EGR System – Deleted on North American Specification (NAS) XK8 Vehicles

MODEL 1997 MY-ON
XK8 Range
VIN
011462-ON

ILLUSTRATION 1

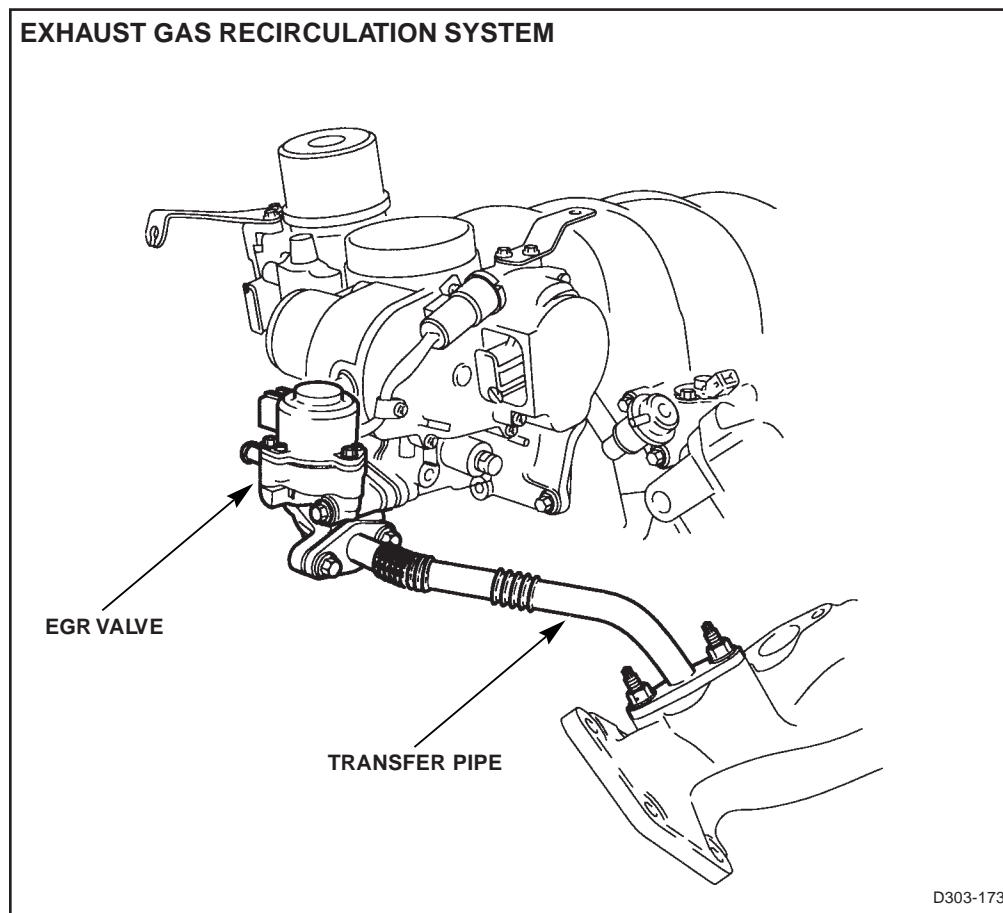
The EGR system (Illustration 1) has been deleted on NAS XK8 models beginning with VIN 011462. Vehicles with or without EGR can be equipped with the latest ECM part no. LJA 1410CA/*** which replaces LJA 1410AN/***.
